SERVICE BULLETIN Volt 9

Replacement of Tyco Contactor

Volt 9 Electric Heaters

Figure 3

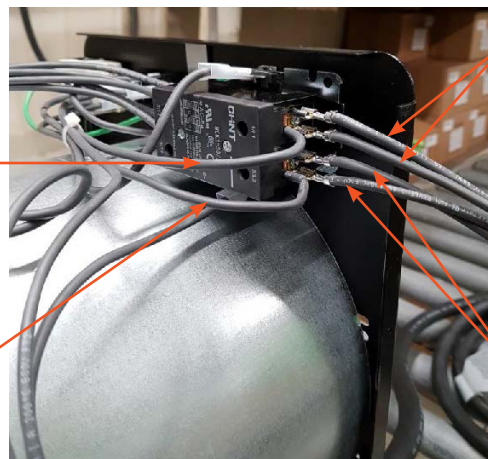
Tyco contactor position 22
Chint contactor position L1
cut off connector of the wire going to
switch S1 position 2A

Tyco contactor position 12
Chint contactor position L2
cut off connector of the wire going to
switch S1 position 1A

Wires going to terminal block X1
position 2

Wires going to terminal block X1
position 1

Figure 4

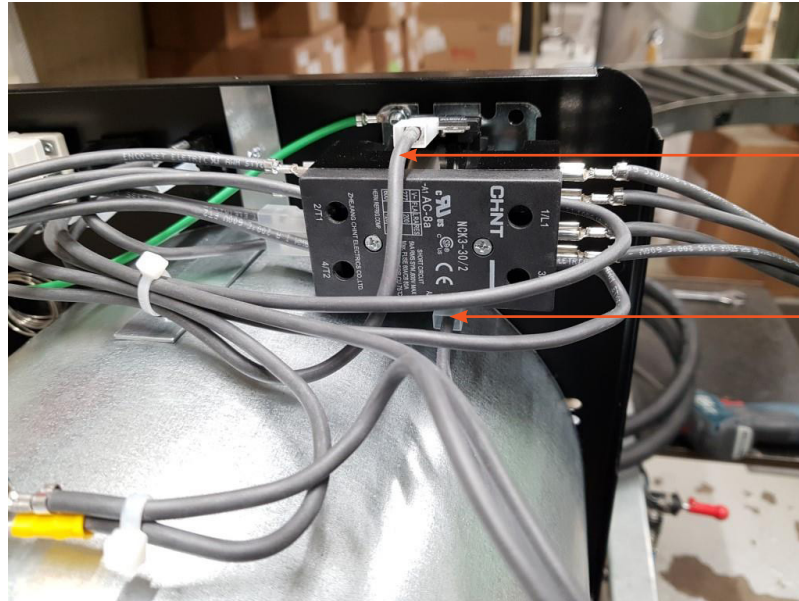
Wire going to switch S2
position 1

Wire going to terminal
block X1 position 4

Figure 5

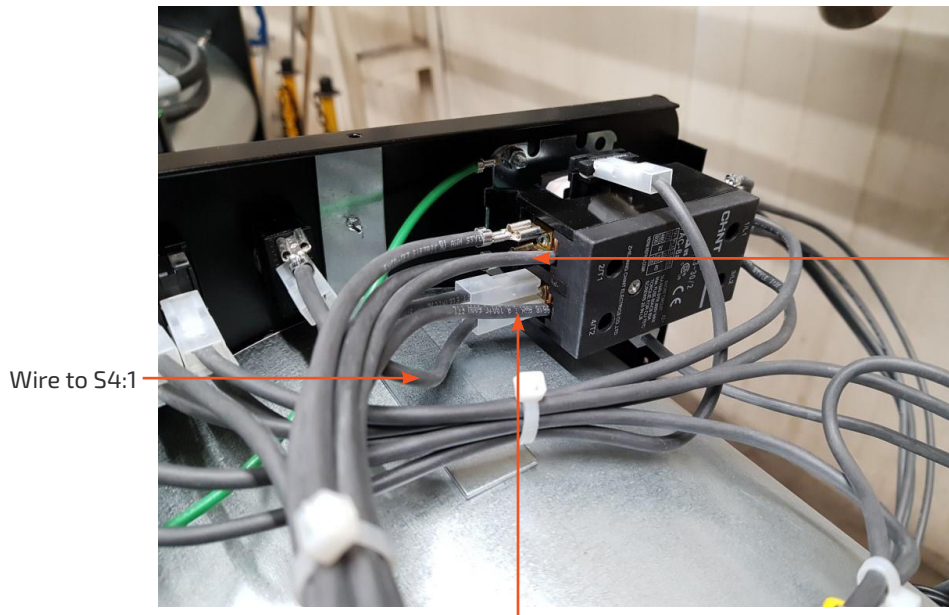
Wire to S4:1

Tyco contactor position
21 / Chint contactor
position T1 cut off 1 piece
connector

Tyco contactor position 11
Chint contactor position T2
cut off 1 piece connector
